RE: Cycling Infrastructure Deficiencies at Murray Creek Ravine on 40 Avenue

Figure 1.1 The subject area is on 40 Avenue just east of 216 Street.

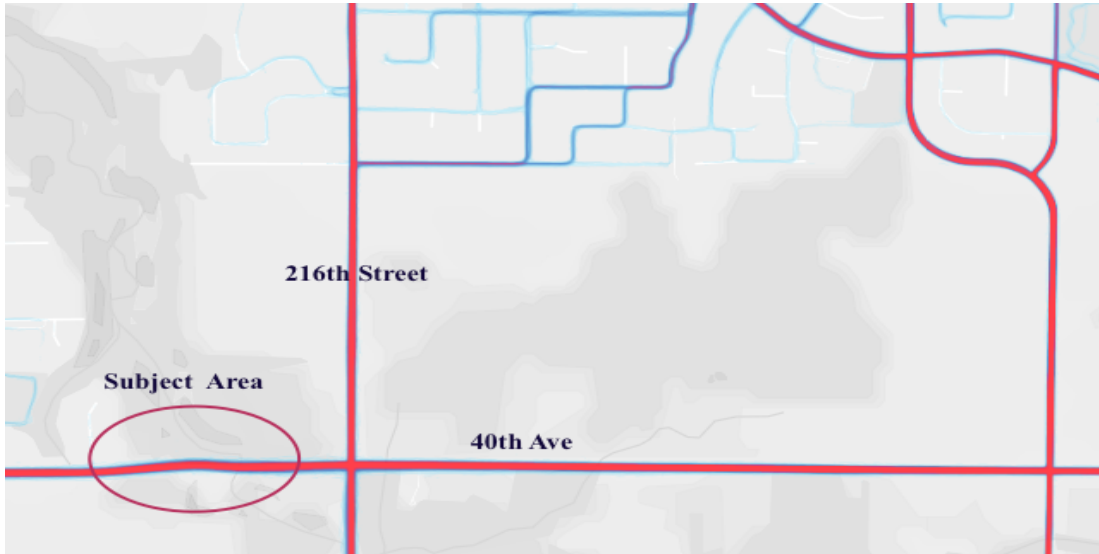
The safety of people who walk (pedestrians) and people who ride (cyclists) is put at risk when they attempt to negotiate their way along a dangerous section of 40 Avenue between 216 Street and 212 Street. 40 Avenue is a busy east-west corridor for passenger vehicles, dump trucks and commercial vehicles. A heat map feature on the STRAVA app, which is used by many recreational and commuter cyclists, shows that 40 Avenue is also a major east-west cycle route in the Township between Brookwood and the Fraser Highway. The nearest alternative east-west connectors for cyclists would be 16 Avenue or 48 Avenue. These routes would be major detours for cyclists.

Figure 1.9

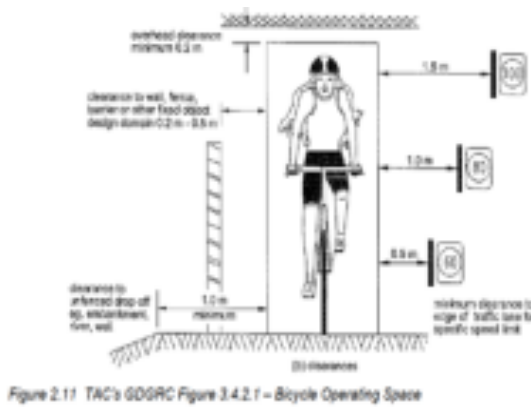
In the interim, an action that can immediately improve safety for users is to designate this section of 40 Avenue as a shared roadway. This can be done by adding sharrows and "May Use Full Lane" signage (Fig 1.9). Additionally, a speed reduction to 50 km/h will advise motorists to expect cyclists in their travel lane. A speed reader board should also be installed for east and westbound motorists. It should be noted that TAC standards state the minimum distance to the edge of a traffic lane for a specific speed of 60 km/h is 50 cm. The distances on 40 Avenue do not meet this standard. Measurements reveal a maximum variance of 28 cm between the curb and the edge of the white line.
